**992-Upper Oil Pan Seal Housing Leak**

**Vehicles Affected**

Models	Model Year	Model Type	VIN Range	Vehicle-Specific Equipment
911	Up to 2021	992	N/A	N/A

Figure 1 - Sharp Edges on Upper Oil Pan

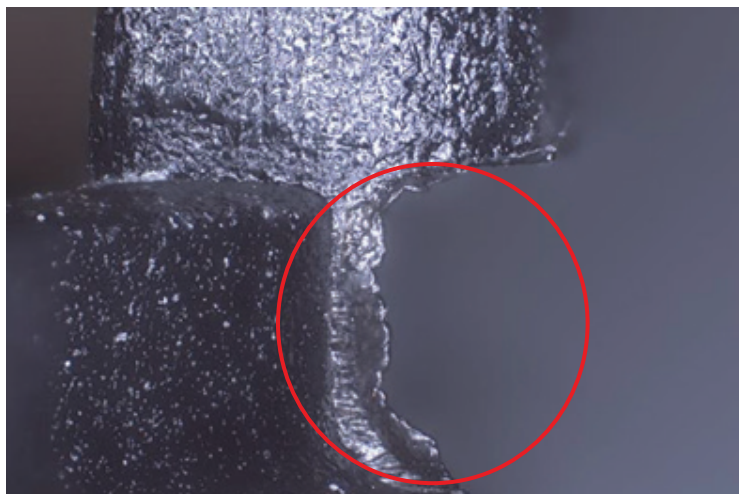
The aforementioned condition may be caused by an injection molding defect known as **flashing** which may be responsible for sharp edges in the upper oil pan housing as seen in **Figure 1**.

Please replace the affected seal (**Part # OPB 115 111 B**) in case any oil leak coming from the rear (engine area) of the vehicle. Before replacing, please remove the plastic body of the new seal and check for the conditions described above. If flashing can be seen on the plastic body, remove it with an appropriate tool and check the seal for damage. If the seal is undamaged, reassemble the plastic body and seal correctly.

**Figure 2 - Effect of Injection Molding Defect Causing Damage in Seal**

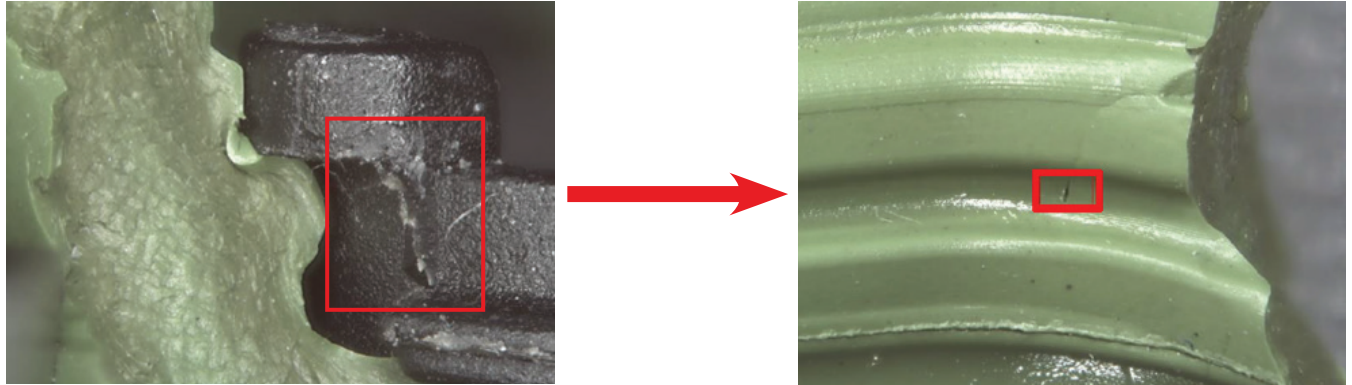
These sharp edges can potentially cause cuts to seals within the oil pan, and cause improper sealing of oil passages. Oil leaks can result from this in the above mentioned conditions. **Figure 2** below shows the damage on the seals caused by the sharp edges pictured in **Figure 1**.
